CALIFORNIA COASTAL COMMISSION

**RECORD PACKET COPY**STAFF REPORT: CONSENT CALENDAR

APPLICATION NO.: 5-98-001

PROJECT DESCRIPTION: Construction of two 35 foot high (each with a 44 foot high roof access structure) two-unit condominiums (4 units total) on two vacant lots with ten parking spaces.

EXHIBIT # 4

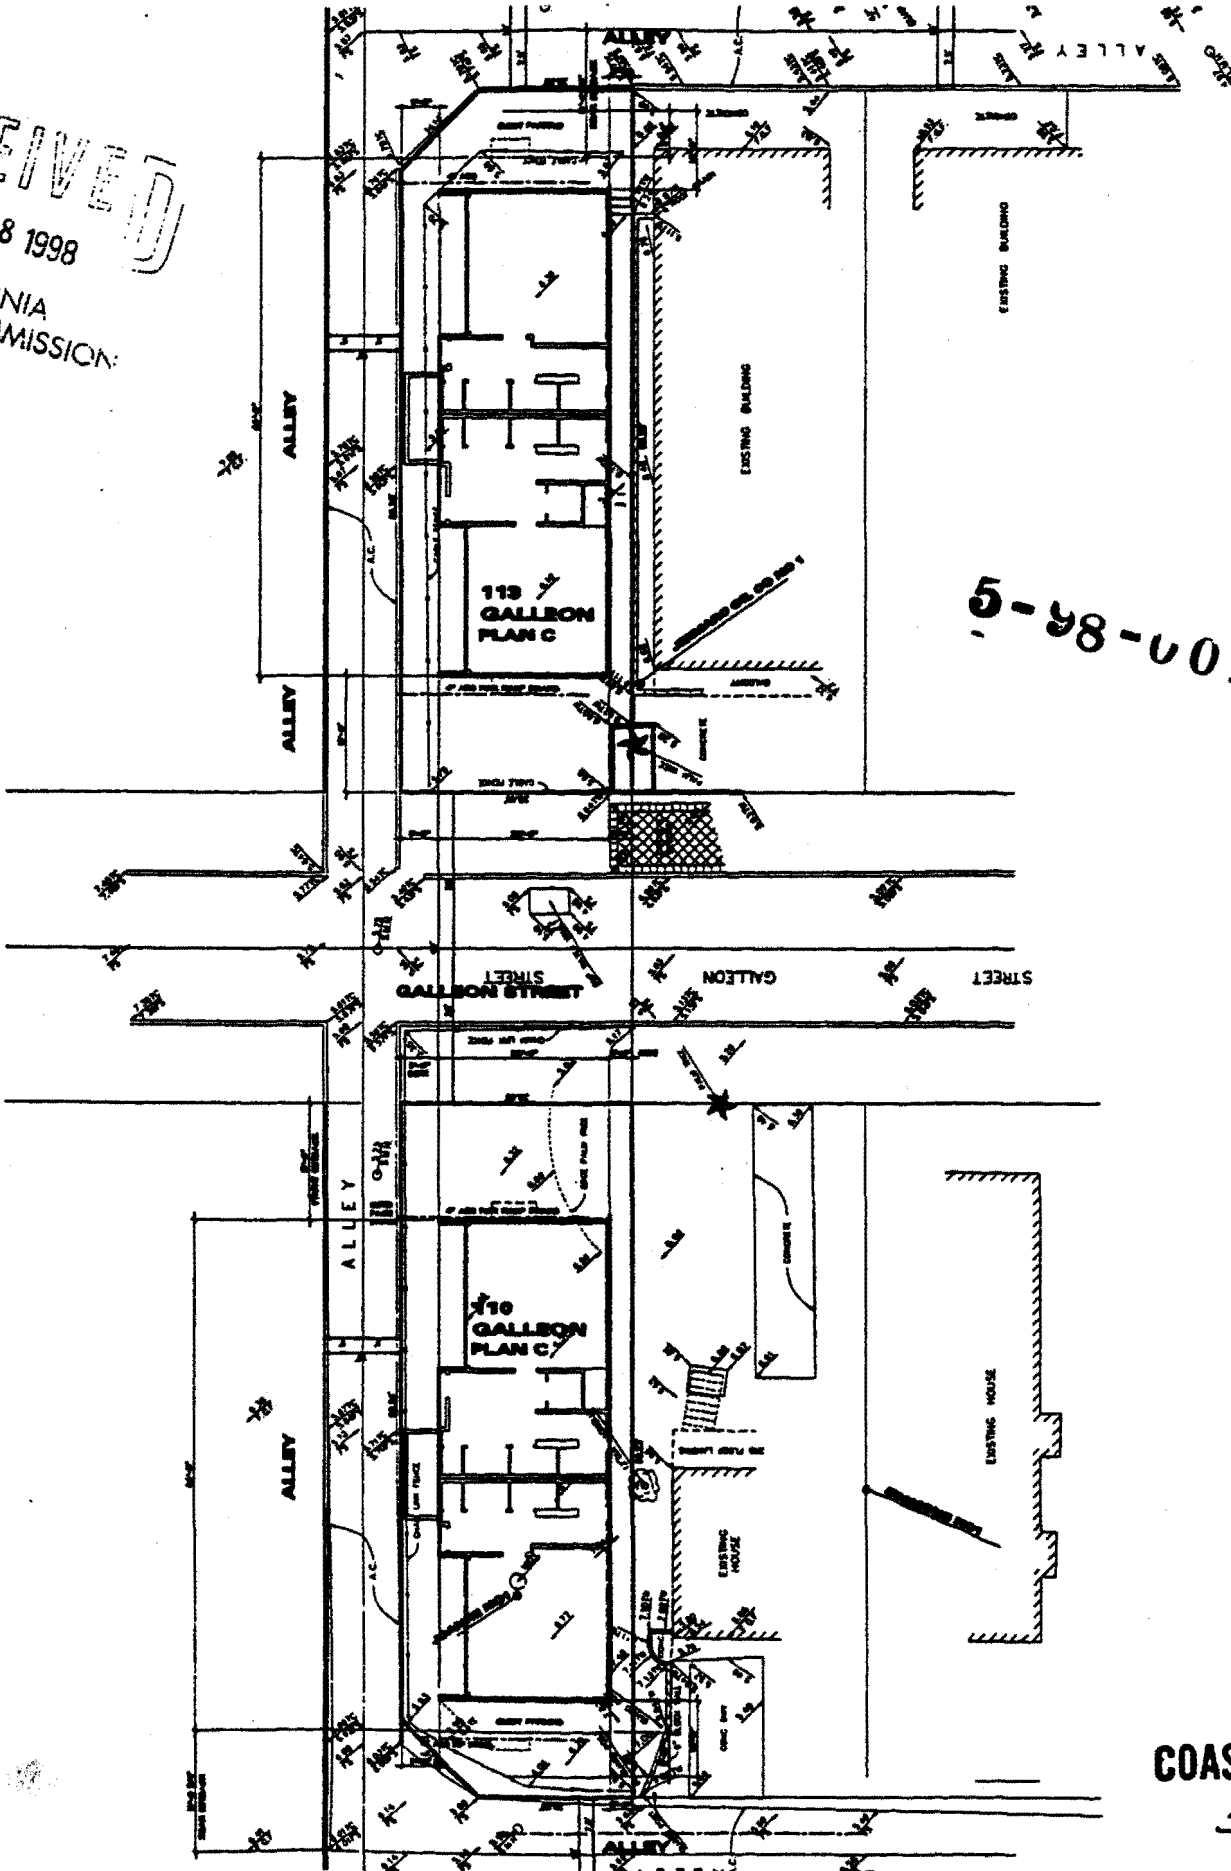
The proposed project does provide front yard areas along Galleon Street for both proposed structures. No curb cuts are proposed on Galleon Street. The ten required on-site parking spaces are accessed from the side and rear alleys (Exhibit #4). Therefore, the proposed project conforms with the character of surrounding area, and as conditioned, is consistent with the Coastal Act's visual resource policies.

To help mitigate the shortage of parking in the area, the Commission has consistently conditioned new development within the Marina Peninsula area of Venice to provide two parking spaces per residential unit and provide provisions for guest parking. The proposed project provides five on-site parking spaces on each of the two lots for ten total parking spaces (Exhibit #4). Two parking spaces are provided for each proposed residential unit (four condominium units), and two additional spaces are proposed for guest parking. As stated above, the proposed parking spaces are accessed from the alleys and no curb cuts are proposed on Galleon Street.

EXHIBIT # 5

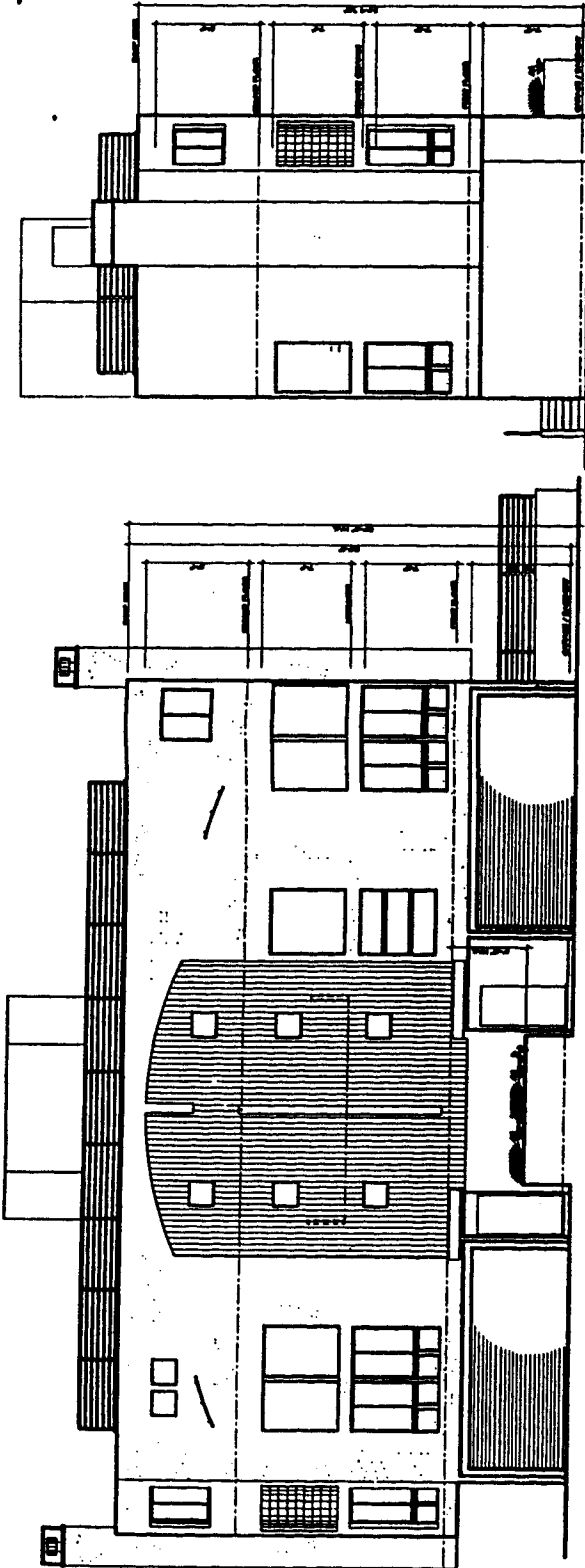
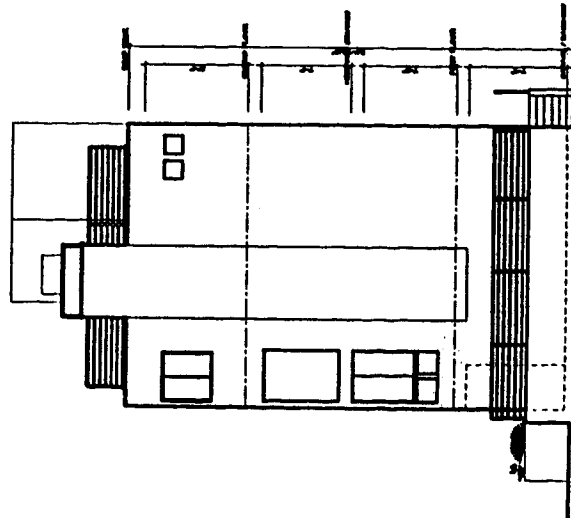
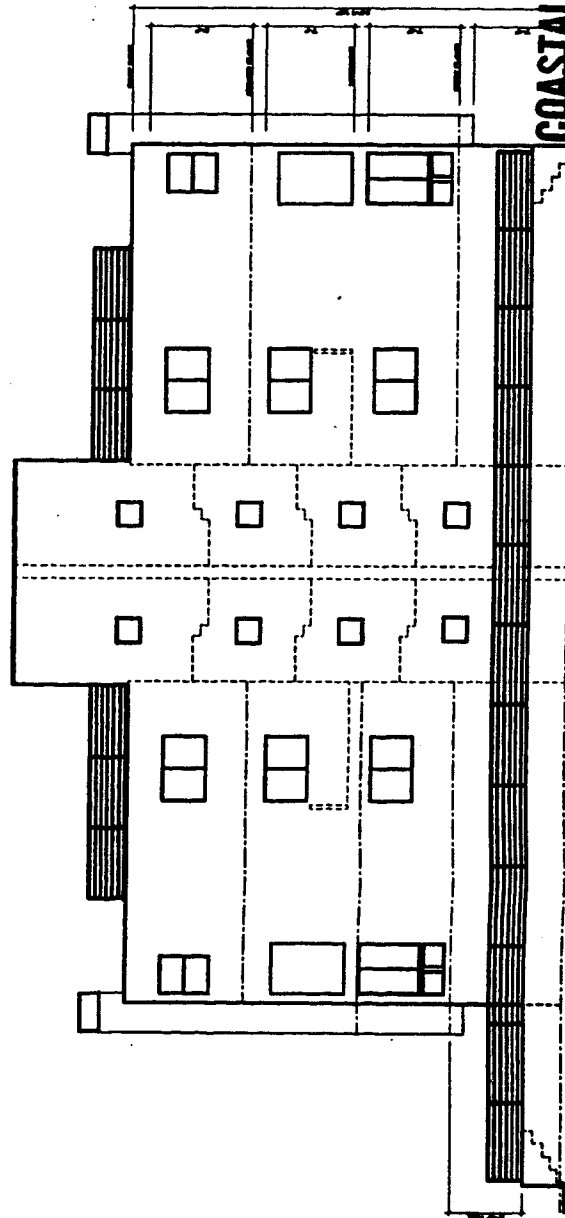
Both of the proposed structures have a roof height of 35 feet (Exhibit #5). However, some parts of the proposed structures exceed the 35 foot roof height. These portions of the proposed structures include roof equipment boxes, chimneys, and two roof access housings. These structures do not extend more than 44 feet above the fronting right-of-way (Exhibit #4).

The height of the roofs shall not exceed 35 feet above the centerline of the Galleon Street right-of-way. Only roof deck railings, parapet walls, chimneys, roof access housings, air conditioning equipment, and solar collectors may extend above the 35 foot roof height limit (as shown on the approved plans). No portion of the structures shall extend more than 44 feet above the centerline of the Galleon Street right-of-way.
